PRODUCT CHANGE NOTIFICATION

#PCN-DCT-A209-10

Business Unit	Product Line Code	Type of Change	Action	Date of issue
DCT	178	Mechanical	Notify Distributors and Field	02/15/2010

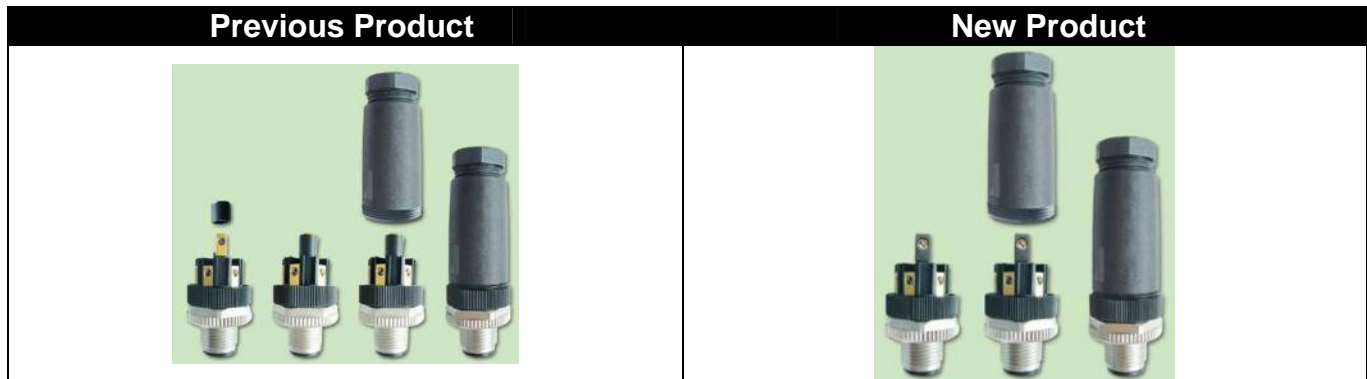
For all 8-pos. plug connectors with screw connection, the insulating tube for the medium (contact 8) screw contact will no longer be necessary. The insulating tube will be replaced by a pre-assembled insulating sleeve. This simplifies the assembly of the conductor to be connected.
